# IRIS-4

Firmware 4.10.2

This document details changes from firmware Version 4.10.1 to Version 4.10.2. for IRIS-4 products.

### 4.3.2 Ethernet to Cellular Bridge

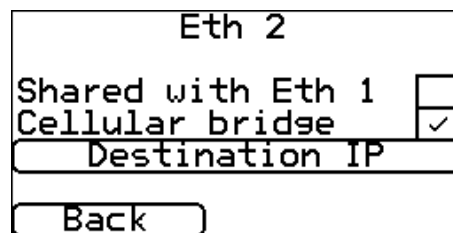
IRIS terminals with cellular connection and two Ethernet ports (IRIS-4 440, IRIS-4 640D) offer the possibility of bridging between the cellular connection and the second Ethernet port (Eth 2). In this case a DHCP server is also provided on the Eth 2 port. This mode of operation is enabled when a SIM card is fitted to the terminal and has attached to the SIM provider's cellular data network and when the Ethernet 2 port is set to 'Cellular bridge' mode, as shown below.

Alternatively, if the device uses a fixed IP address, this IP address should be set in the 'Destination IP' on the touch screen menu as shown above. The Gateway IP address set in the device should be set to the same IP address as the device but with the last part of the IP different such that:

### 4.3.3 Modified Support for Vanderbilt SPC Panels via Ethernet

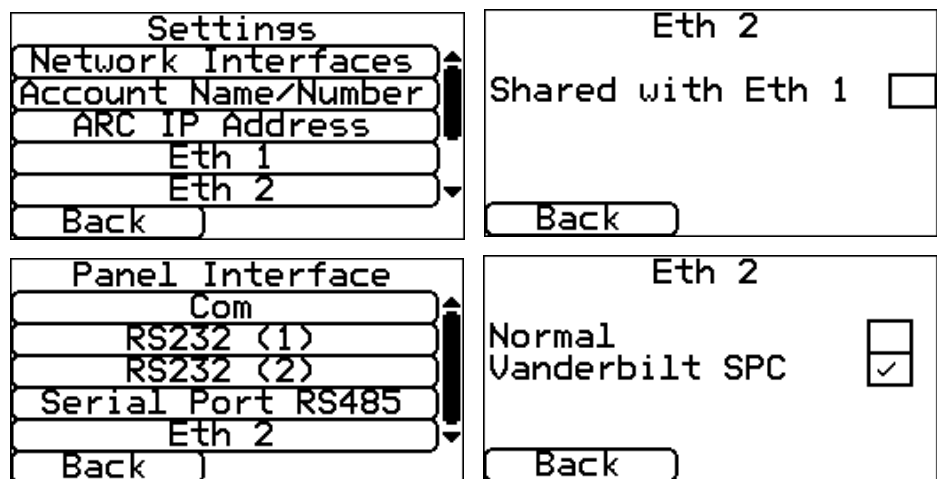
There has been a modification to the way this works, driven by the fact that Microsofts' Dial-up Networking function is no longer supported in Windows 10 in the same way as it was on earlier Windows versions. This means that remote access to the panel from Siemens SPC Pro software is no longer possible using the combination of Dial-up Networking and the IRIS Remote Service App. Therefore, an alternative way of supporting SPC Pro connection via AddSecure 's Link service has been provided. The same can also be done with any SIM card that provides remote connection from an external IP source.

- 1) The IRIS terminal now includes a DHCP server on the second Ethernet interface so the panel should be set to use DHCP, rather than a fixed IP address.

- 2) The monitoring centre IP address (the EDP IP address) set in the panel must be the IP Gateway address given to the panel by the IRIS DHCP server. This IP address can be obtained from the panel (e.g. via the keypad).

- 3) For remote access to the panel using SPC Pro, the destination IP address for the panel must be the IP address associated with the SIM card fitted to the terminal. Depending on the SIM card provider this may require a connection between the PC running SPC Pro to the SIM card providers own data network. In the case of AddSecure's Link service this uses a connection using OpenVPN with a Certificate provided by AddSecure.

- 4) The IP Address and Remote Access settings have been removed from the terminal's touch screen menu as they are no longer required. When selecting Siemens mode, the option 'Shared with Eth 1' is automatically deselected.

#### 4.3.4 ESMI Fire Panel Support

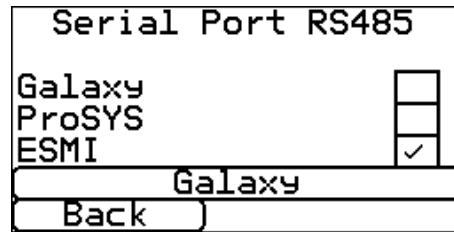
Support for Fire Panel serial interfaces has been extended to include ESMI fire panels on the RS485 port.

### 4.7.2 Tamper Restore

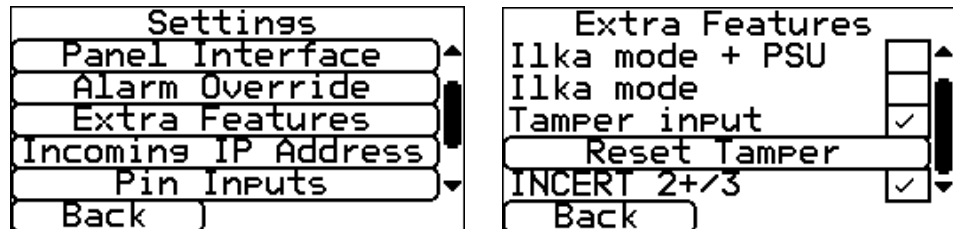
This enhancement has been made for compliance to Belgian Incert standards and is only applicable if 'INCERT 2+/3' mode has been selected on the Touch Screen->Extra Features menu.

If a tamper switch activation occurs (including activation of the tamper input on non-cased variants), it does not restore automatically, it must be restored via the Touch Screen->Extra Features menu 'Reset Tamper' button.

If the tamper physical condition has been restored before 'Reset Tamper' has been selected, the reset button will be removed and the tamper restore message will be sent to the monitoring centre. If not, the button will be removed and the tamper restore will be sent when the condition is restored.

### 4.7.3 Cellular Mode

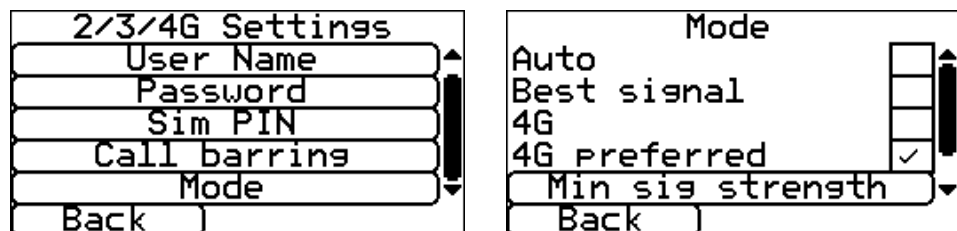
A Cellular Mode setting menu has been added to the 2/3/4G settings menu to select the Cellular technology used.

- Auto – the terminal will adopt the technology that is selected by the combination of the SIM card configuration and the network operator.
- Best signal – the terminal will select the technology with the highest signal strength (the default setting in the previous firmware release).

- 4G – fixed to 4G only. Note if there is no 4G available the terminal cannot fall back to 2G or 3G and so cellular communication will not be possible.

- 4G preferred – 4G is selected as long as it is available and above the minimum signal strength selected. Note if there is no 4G available the terminal will fall back to 3G or 2G if available.

- 2G + 3G – the terminal will not use 4G.
- 3G - as '4G' but fixed to 3G.
- 3G preferred – as '4G preferred' but 3G is selected if available and above the minimum signal strength specified.

- 2G - as '4G' but fixed to 2G.
- 2G preferred – as '4G preferred' but 2G is selected if available and above the minimum signal strength specified.
- Enhanced roaming – the same function as available on the previous version of software.

#### 4.7.4 'Fail to Communicate' Relay output

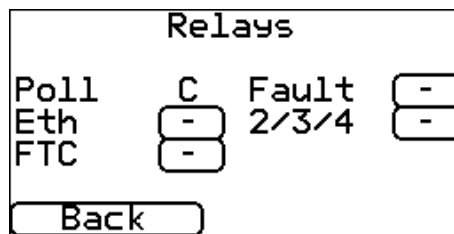
A relay can be selected to indicate 'Fail to Communicate'. This is found in the 'Trouble Reporting' 'Via Relays' menu.

#### 4.7.5 Relay Invert Setting

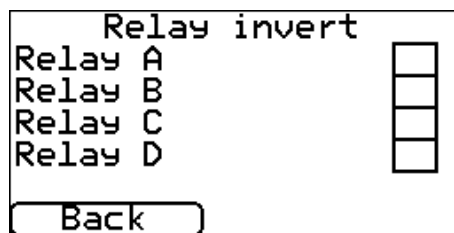
A relay invert setting is available in the 'Relays' menu.

#### 4.8.1 Operation with Galaxy Flex alarm panels

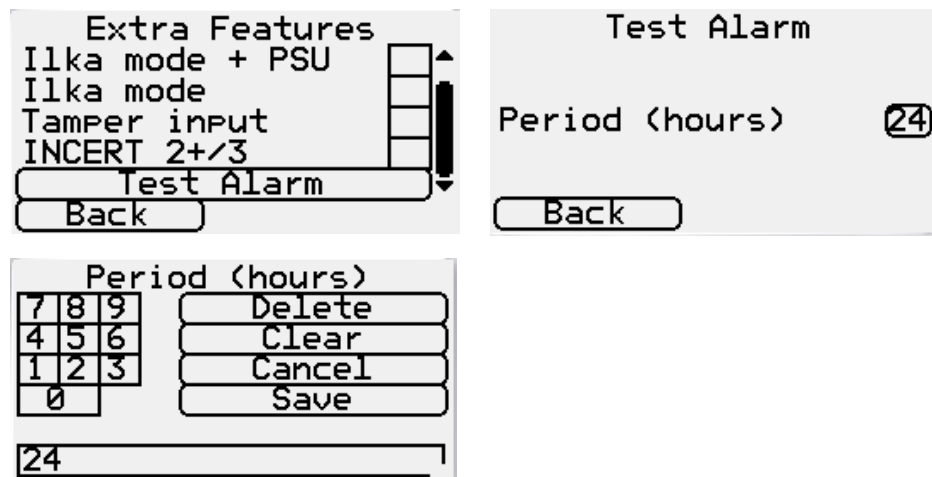
It has been identified that when an IRIS terminal is connected to a Galaxy Flex alarm panel via the RS485 bus, some events can cause it to generate a Tamper alarm within the panel. This release prevents this happening.

#### 4.9.4 Selection of Cellular Technology

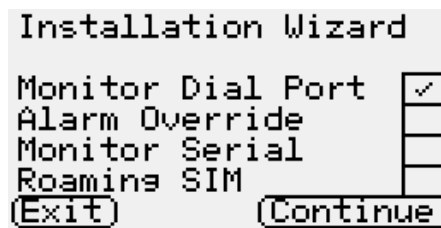
By default, IRIS-4 terminals select the cellular technology (2G, 3G or 4G) with the highest signal strength. It has been found that if one of the technologies is available on the cellular network to which the terminal has local access, but is not able to support data transmission, then this process is not optimum and the terminal may not select the technology with highest signal strength. This situation has been resolved.
